COMBUSTION ENGINEERING, INC.

Enclosure 1-NP to LD-83-031

Response to NRC Questions Regarding
System 80TM CPC/RPCS

April, 1983

Figure 1

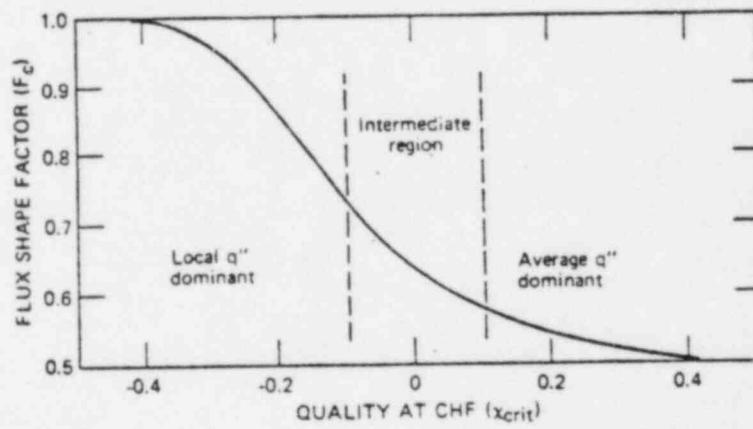
The CPC change No. 4 modifies the calculation of the transient non-uniform heating correction F-factor F_k , by updating the F_k based on the direction of the change in quality margin. Explain what the coefficients QLCOF1 and QLCOF2 are and describe how they are calculated. Also describe how the expression for updating F_k from the static F- factor is derived.

representative behavior of the F-factor as a function of quality can be seen from Figure - 1 (Reference 11.1). [

The new expression follows the trends of the F-factor more accurately and therefore provides a more accurate assessment of the updated DNBR than the previous expressions. This results in increased operating margin.
